Traffic and Transportation

In accordance with the MEPA Scope, this chapter directly responds to agency and public review comments within MEPA jurisdiction. Copies of the Secretary's Certificate on the Draft Environmental Impact Report (DEIR) and each comment letter received during the public review period of the DEIR are included in this chapter. This chapter provides responses to those letters.

Table 6-2 Response to Comments

Northland Newton Development
Newton, MA

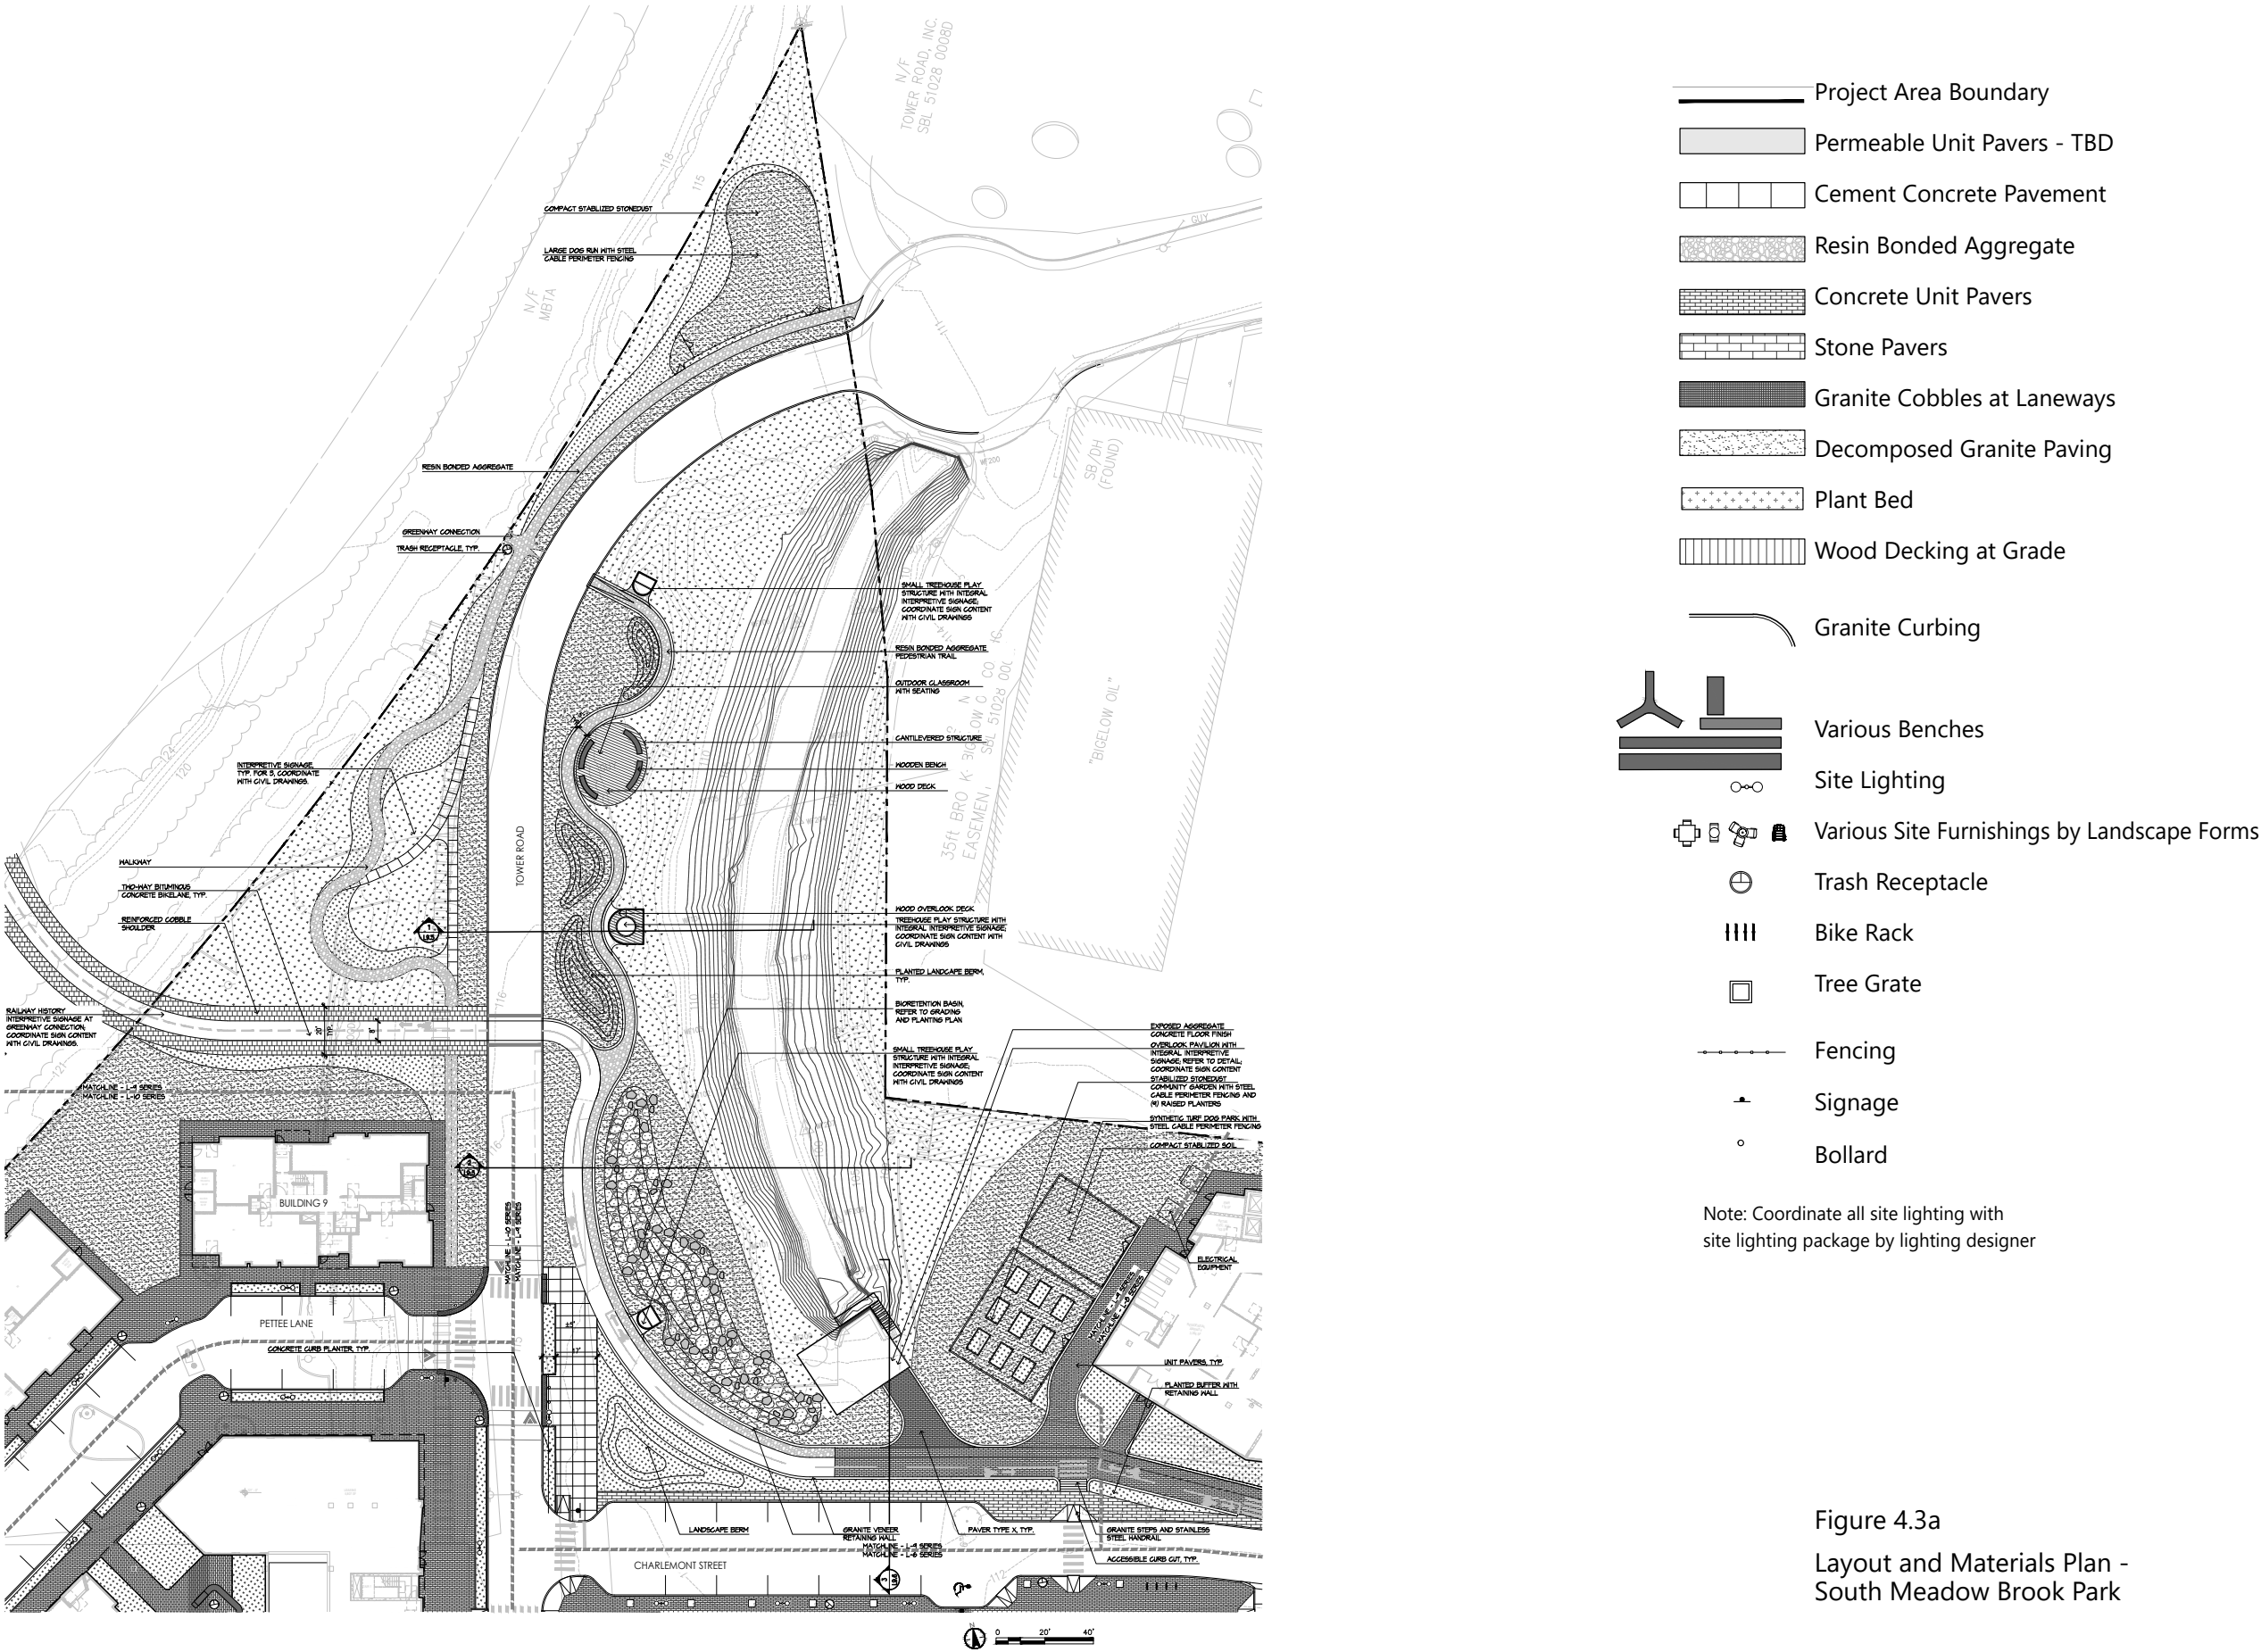
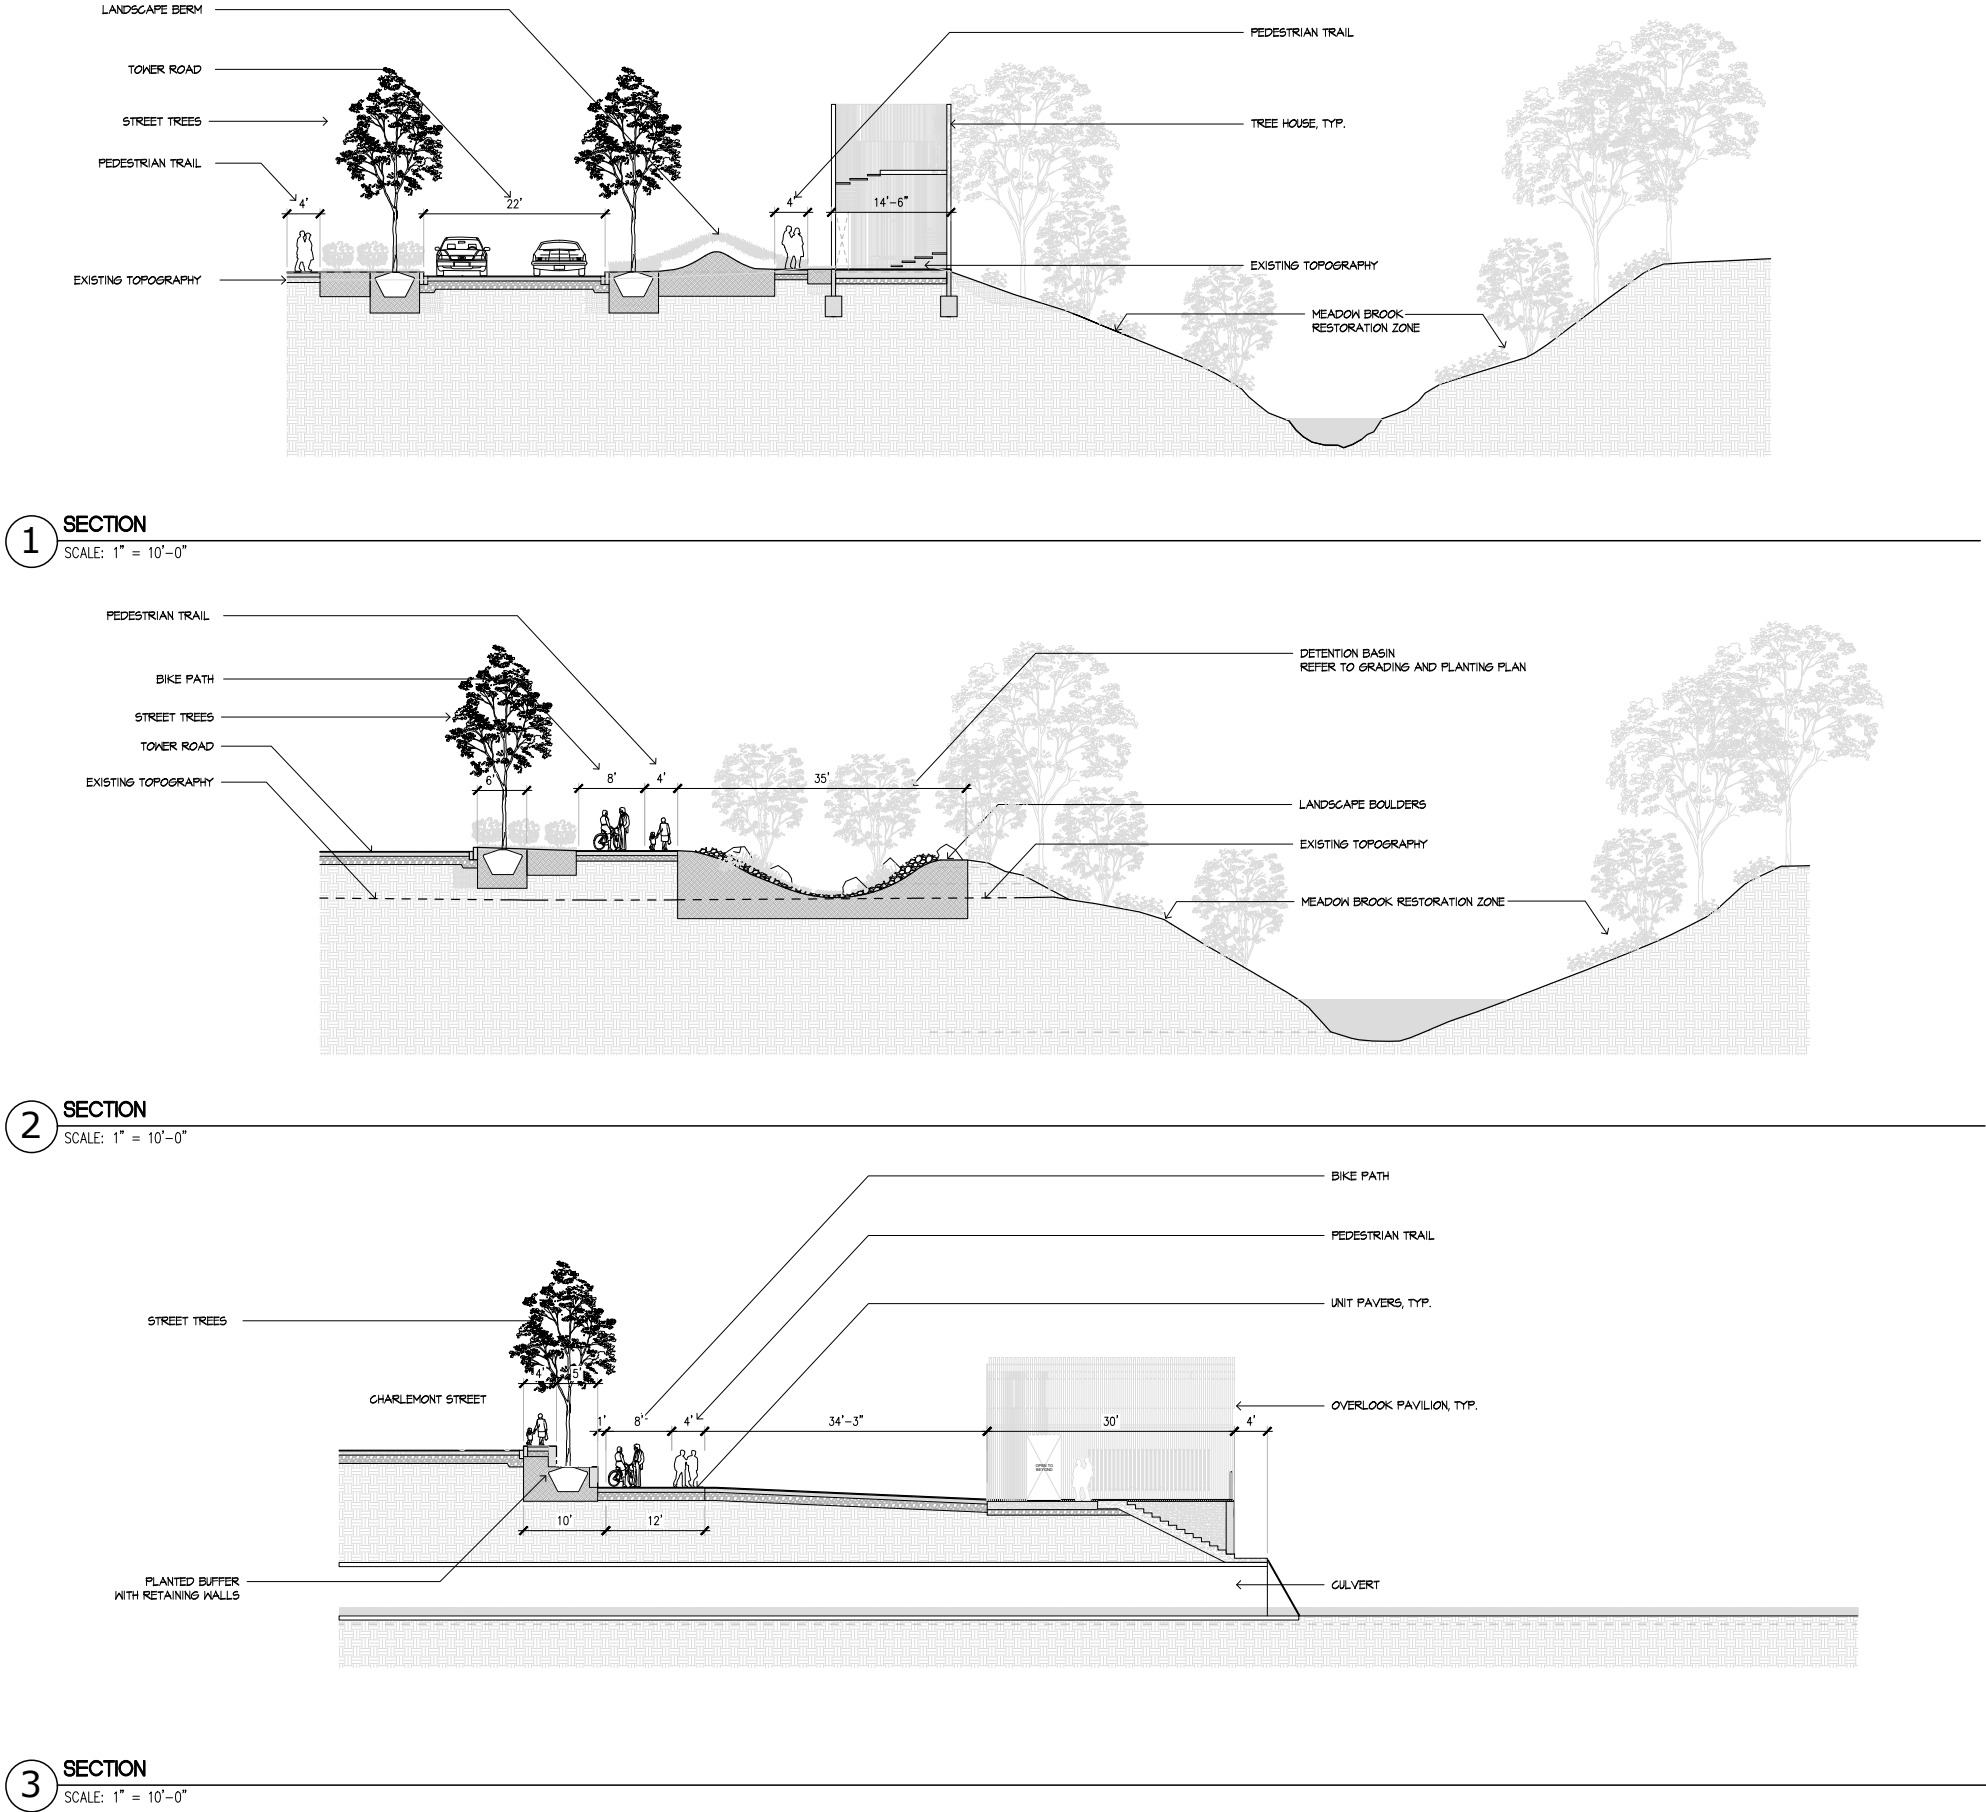
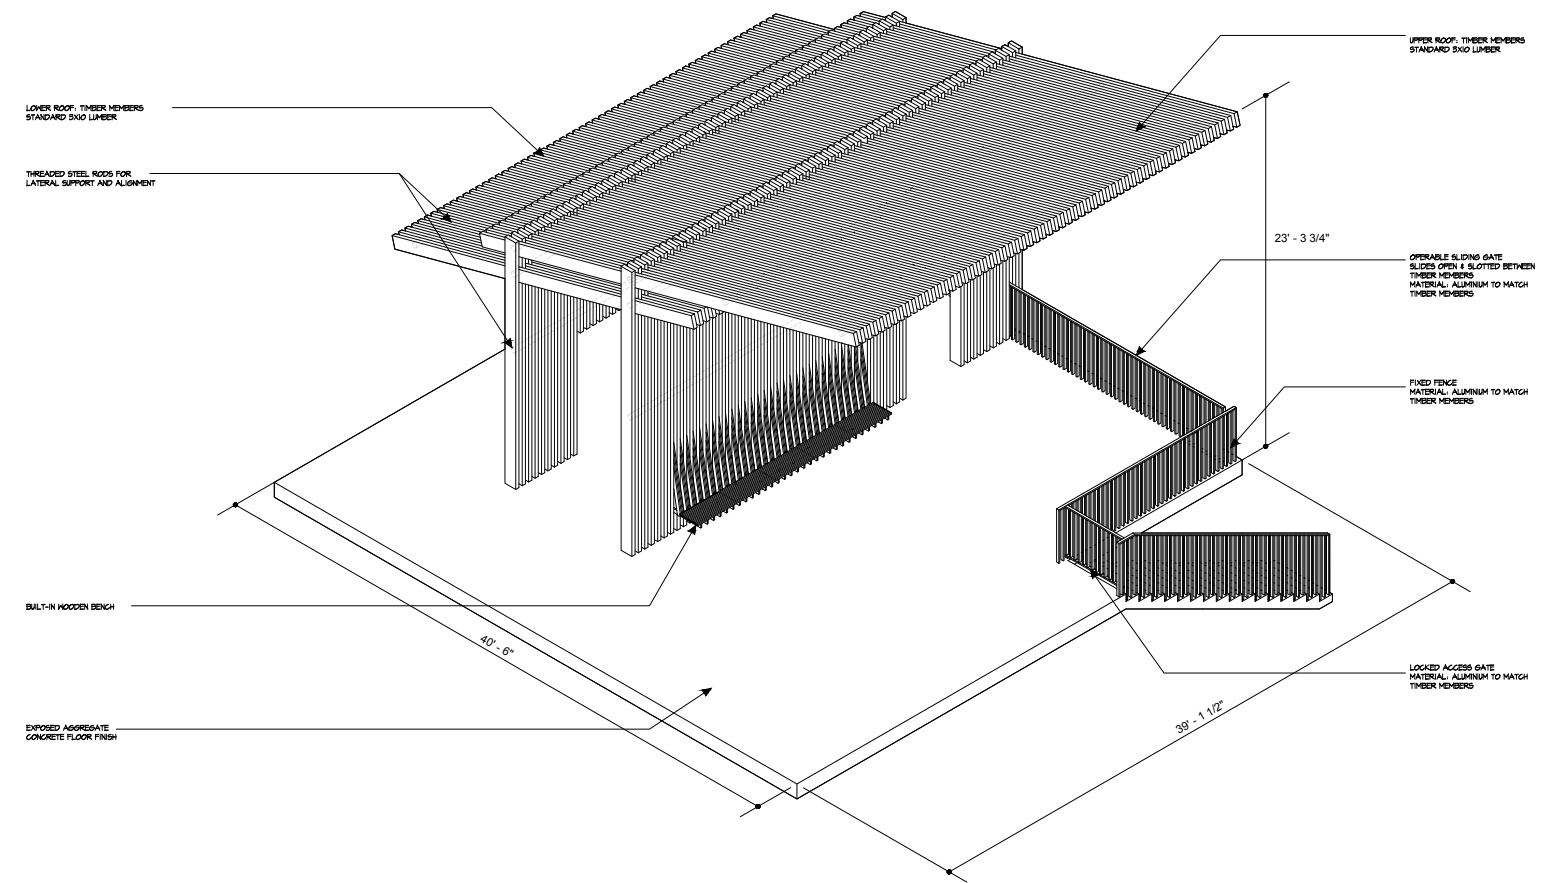
1.35	The FEIR should provide a plan clearly showing all project components within the Riverfront Area, quantify potential impacts to all wetland resource areas and floodplain and describe mitigation measures.	Figures 4.1 - 4.4h provide information on the plantings proposed for the Project and work within the existing daylighted section of South Meadow Brook. No work is proposed within Land Under Waterbodies and Waterways. Refer to Section 4.1 of Chapter 4, <i>Wetlands</i> for more details.

Comment #	Commenter	Comment	Response
5.04 CRWA	<p>Finally, given that the project includes work proposed in the 200 ft. Riverfront Area (RA) of the daylighted section of the South Meadow Brook, the FEIR should contain more details regarding the nature of the work. While the Proponent has committed to improving the RA by reducing the area of pavement and by planting a diverse selection of native trees, shrubs, and other plants, the FEIR should include a much more comprehensive stream restoration plan and supporting details.</p>		<p>Section 4.1 of Chapter 4, <i>Wetlands</i> includes a description the restoration of elements of the South Meadow Brook Riverfront Area. Figures 4.1 - 4.4h provide information on the plantings proposed for the Project and work within the existing daylighted section of South Meadow Brook.</p>
